**Rolls-Royce & Bentley
motor cars**

Volume 1

TSD 4446

SERVICE INFORMATION SHEETS INDEX FOR TSD 4446

Fig. 2
A Earlier Tapered nose end crankshaft
B New parallel nose end crankshaft

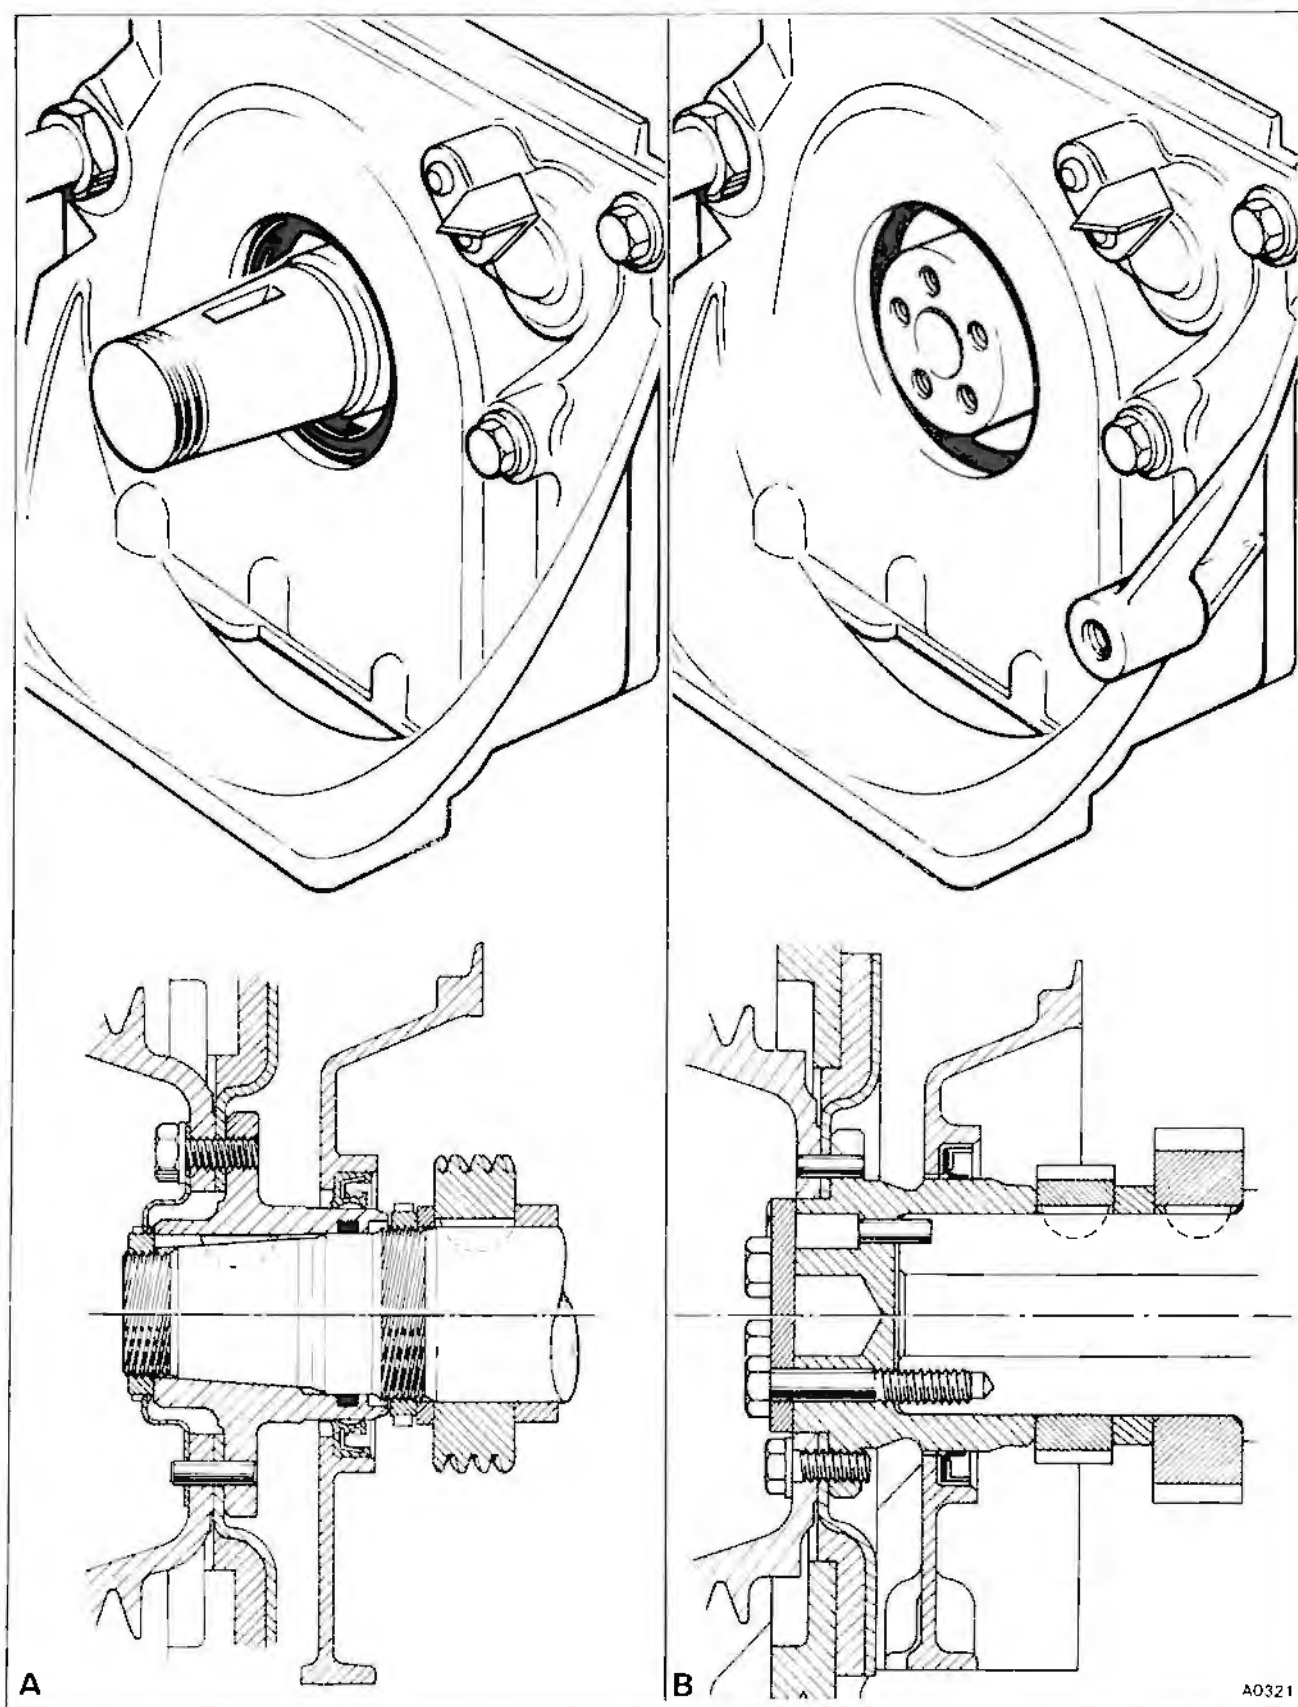
The new crankshaft features a parallel 'nose end' as opposed to the tapered 'nose end' of the previous type. The purpose of the change is to improve the method of retaining the timing gear, oil pump gear, and pulley flange.

Changes have been made to the method of retaining the timing gear, oil pump gear, and pulley flange. The gears, which are a push on fit, are located on Woodruffe keys. The pulley flange, which is also a push on fit, is located in the end of the crankshaft by a hollow steel dowel. The complete assembly is retained on the crankshaft by five setscrews and a hardened steel disc.

An exploded view of the new crankshaft is illustrated in figure 1, while figure 2 illustrates the difference between the old and new crankshafts and associated parts.

Fig. 1 New Heatshield, Hose and Clipping Arrangement

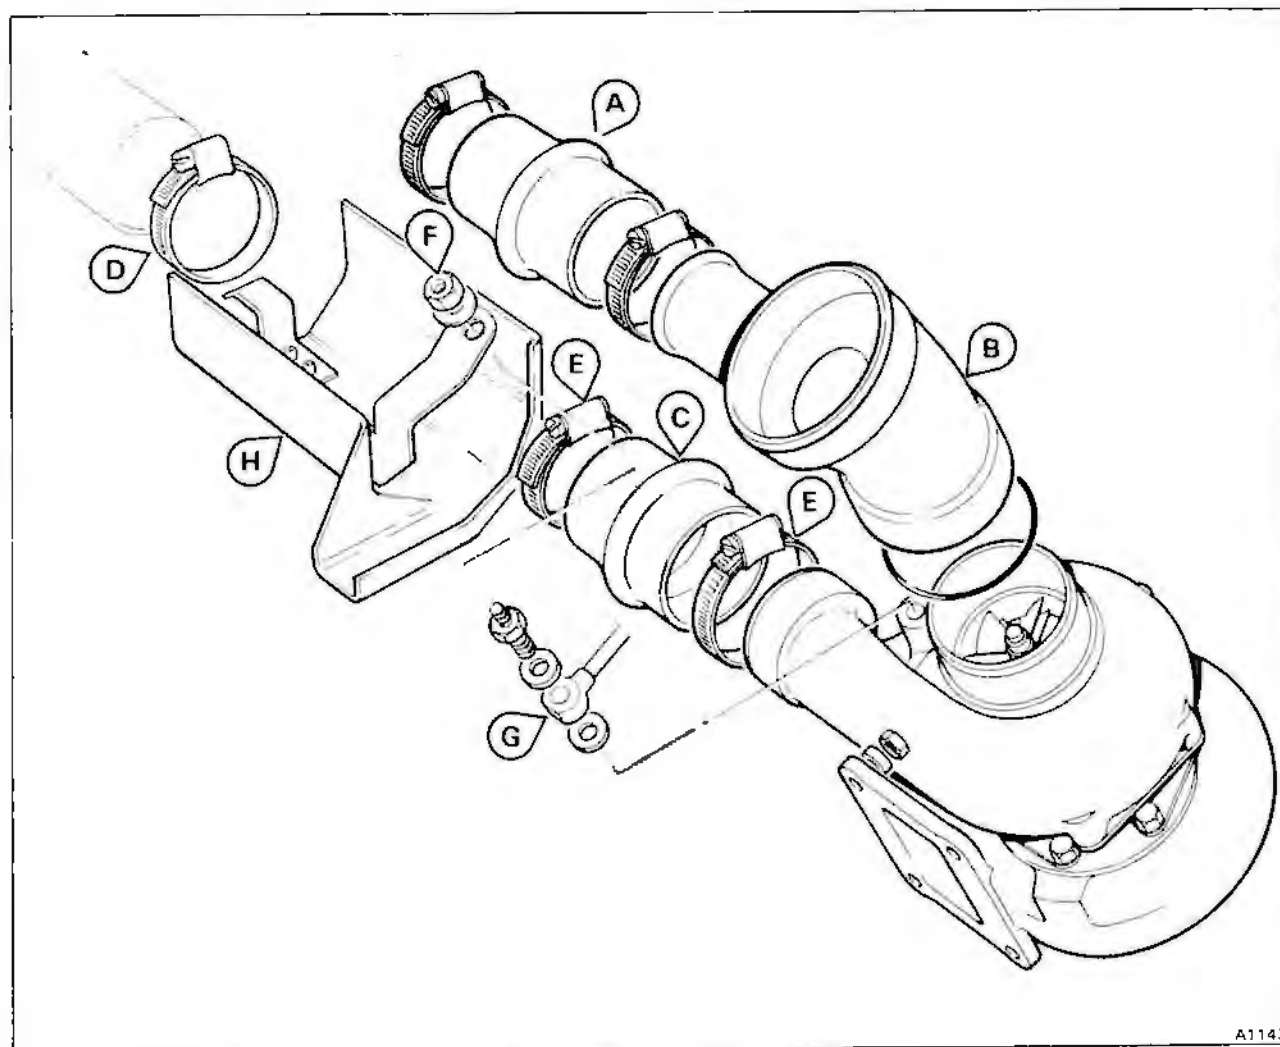
- A Upper convoluted hose (dump valve line)
- B Intake elbow
- C Lower convoluted hose (turbocharger to air chest feed line)
- D Heatshield retaining hose clip
- E Lower convoluted hose retaining hose clips
- F Nut and washer securing heatshield and intake elbow
- G Boost signal pipe
- H Heatshield

Fig. 1

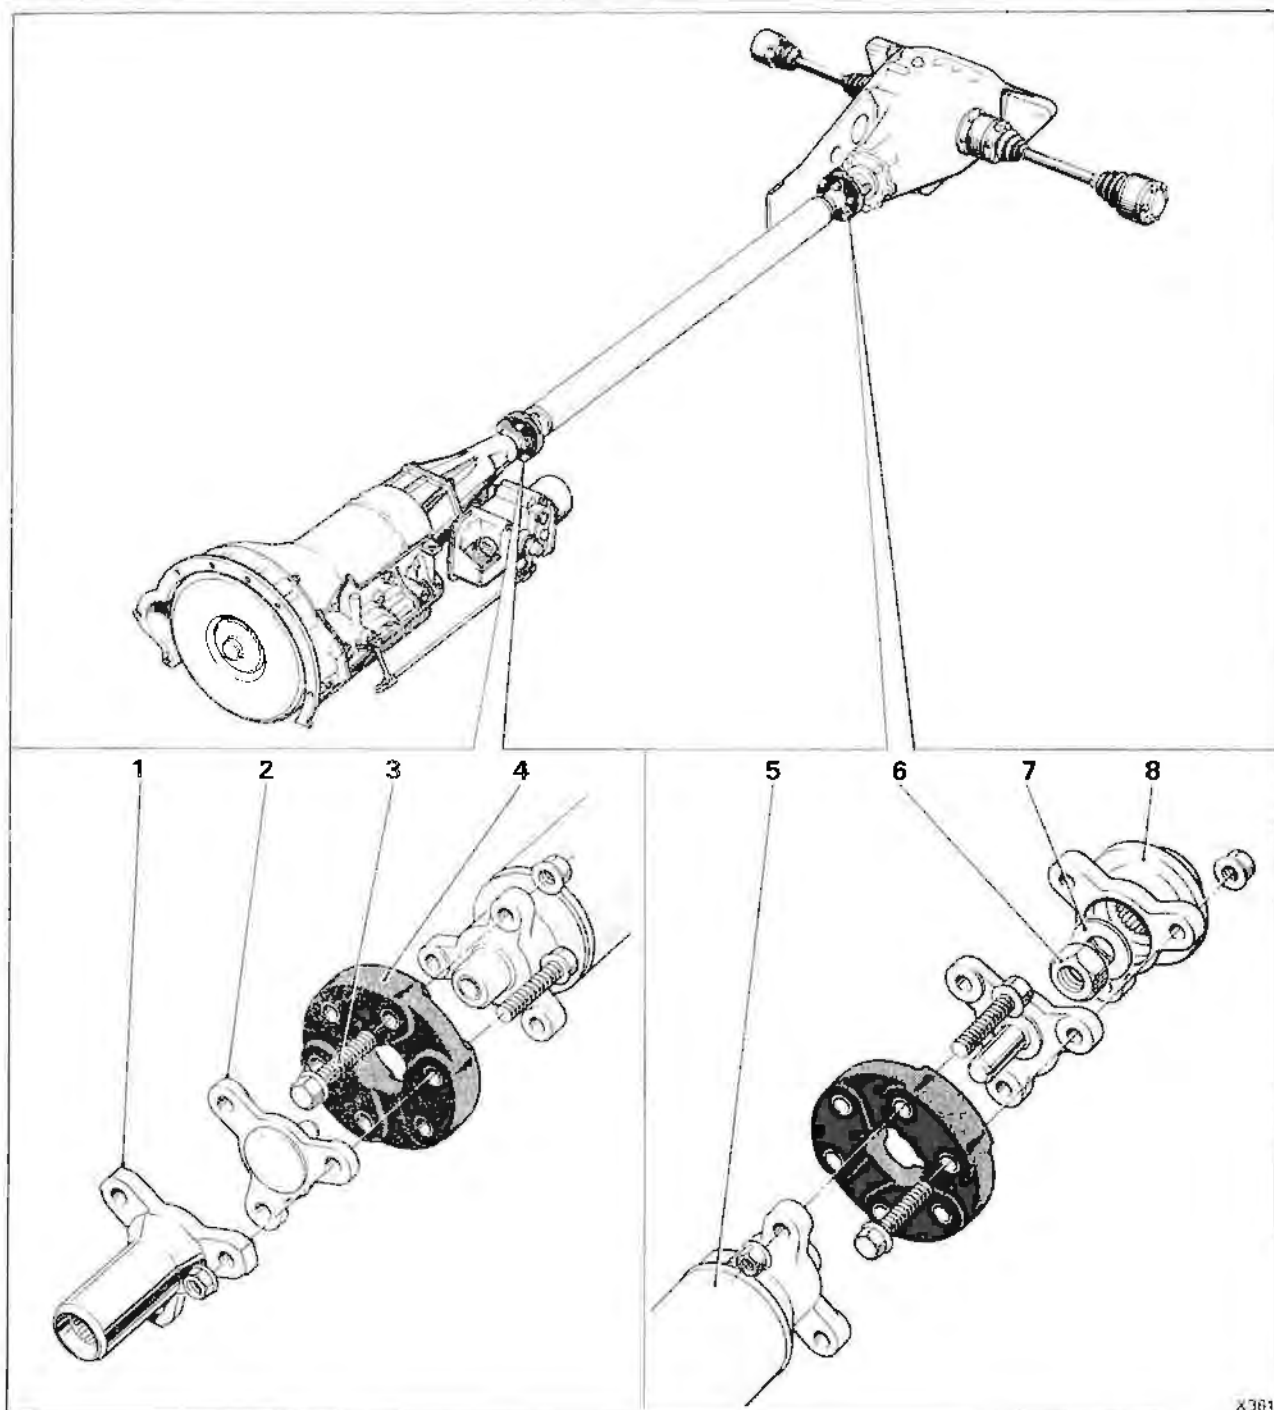
From the above vehicle identification numbers a new propeller shaft incorporating flexible rubber couplings is being fitted (see fig. 1). This service information sheet has been issued to explain the changes which have been made with the introduction of this new feature.

1. Gearbox flange (UG 14921)
2. Spigot flange (UG 14924)
3. Bolts (SPM 1684)
Nuts (SPM 1686)
4. Rubber flexible coupling (UG 14853)
5. Propeller shaft assembly - Short wheelbase cars (UG 14940)
Propeller shaft assembly - Long wheelbase cars (UG 14941)
6. Retaining nut (SPM 1665)
7. Washer (UG 14898)
8. Final drive flange (UG 14920)

Fig. 1

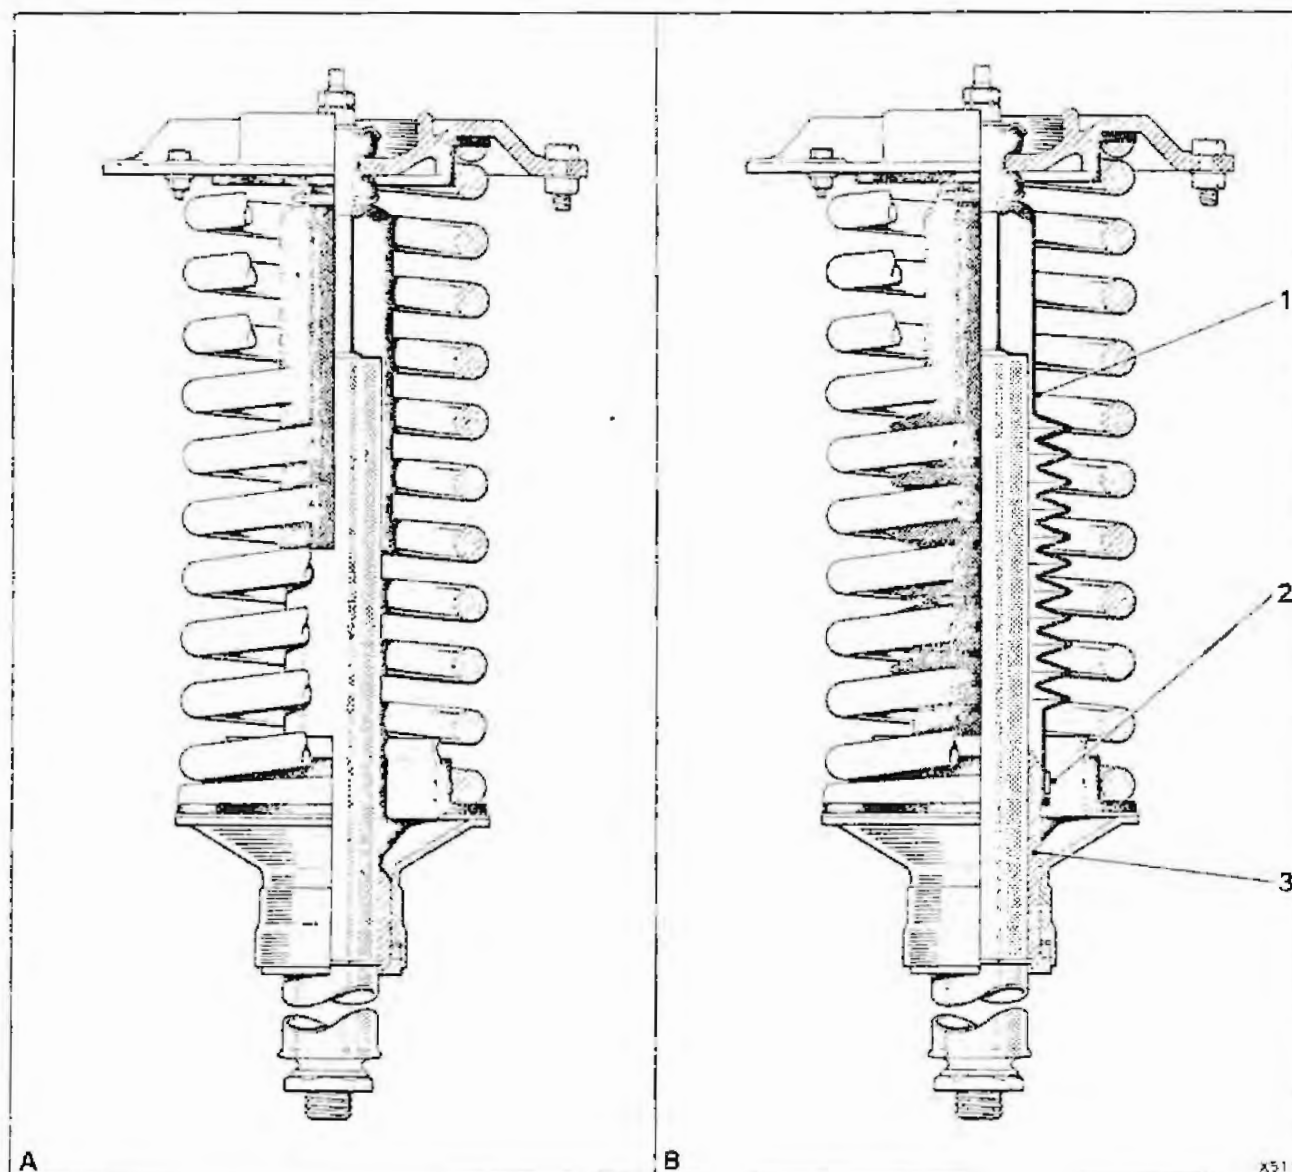
Changes have been made to the front suspension dampers in order to provide improved sealing. A convoluted rubber boot is now fitted, replacing the plain rubber boot originally used. To accomodate the convoluted boot, the damper sleeve has been modified (see fig. 1).

A Early damper boot arrangement

Fig.1

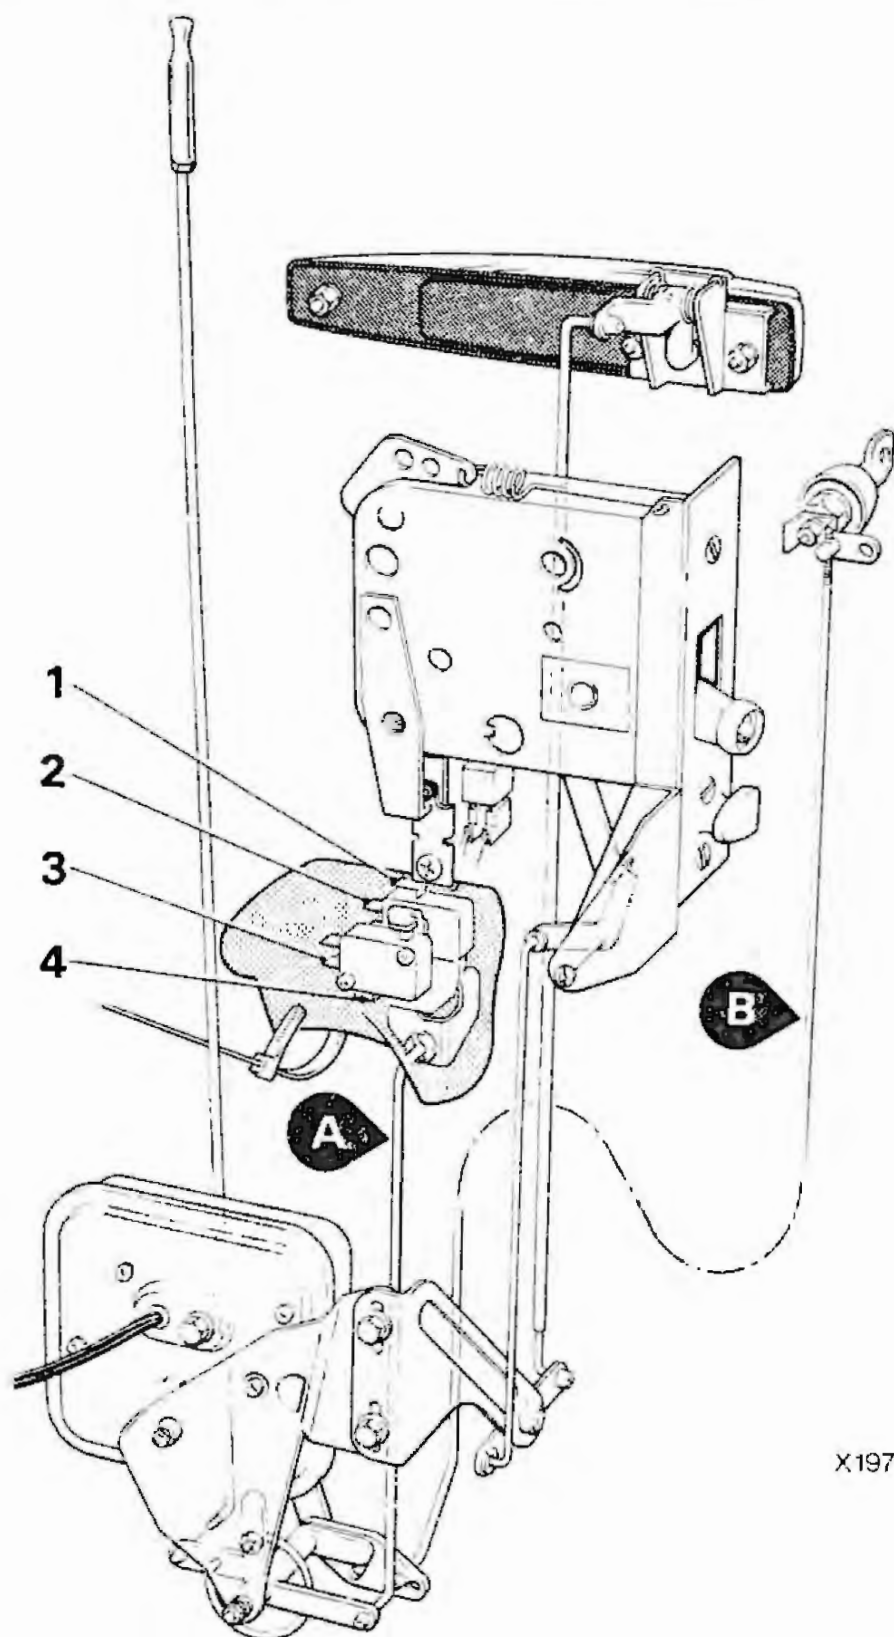
The new switch assemblies are situated between the lock control lever and solenoid relay lever on the door locking mechanism as shown in figure 1.

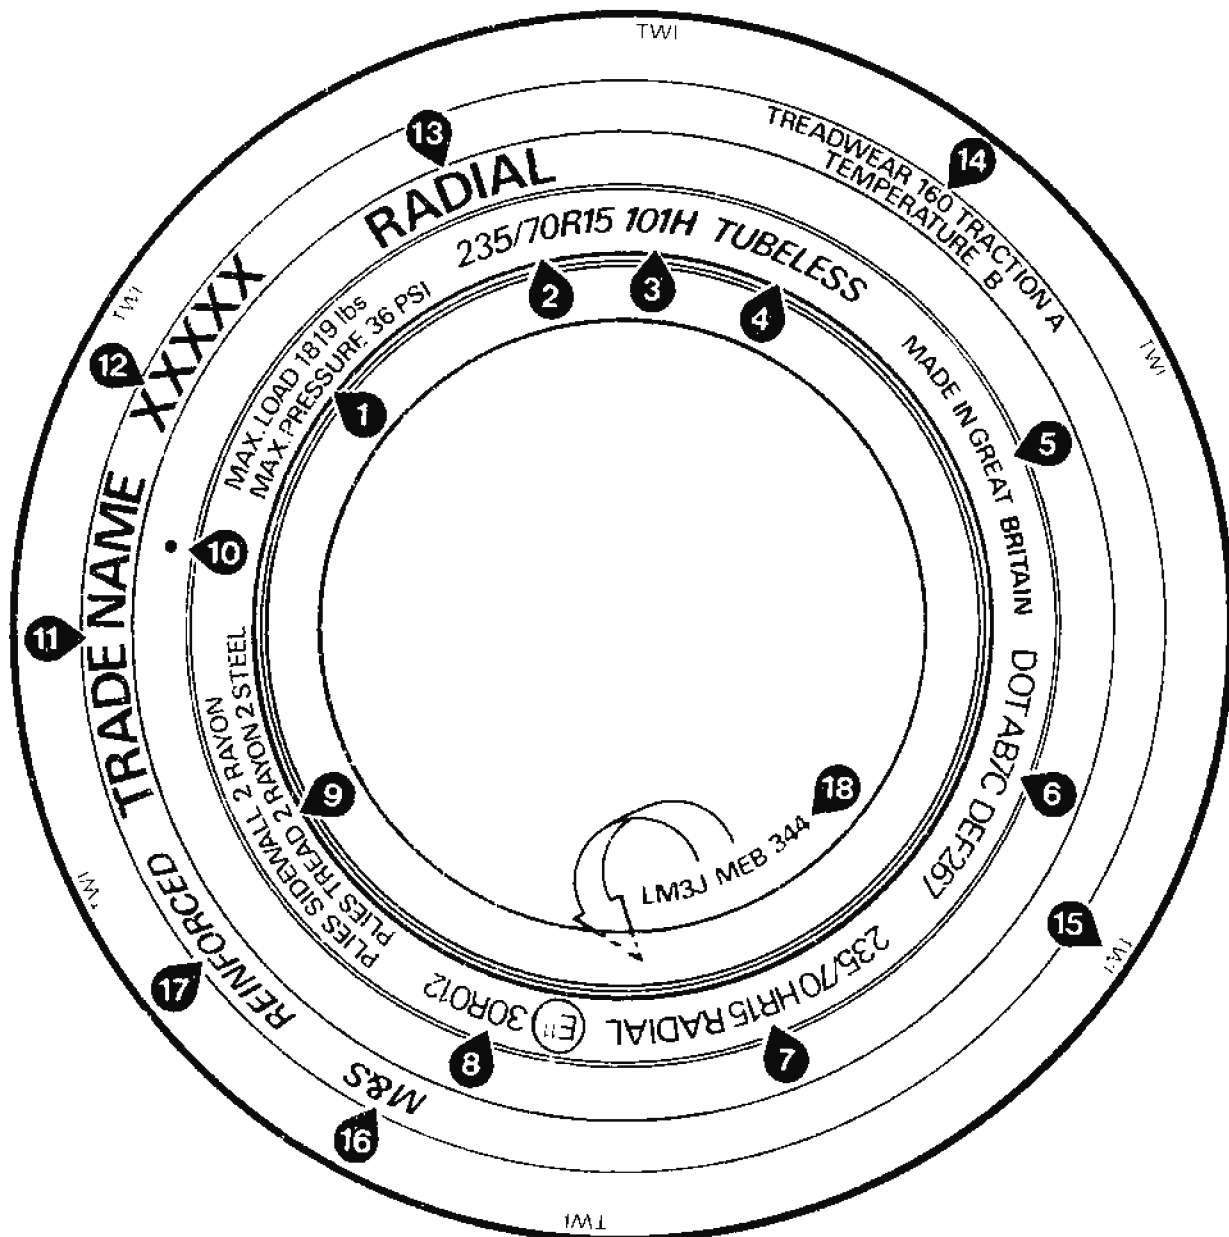
Figure 1, item 1 shows the new 'Maximum Load' figure and location.
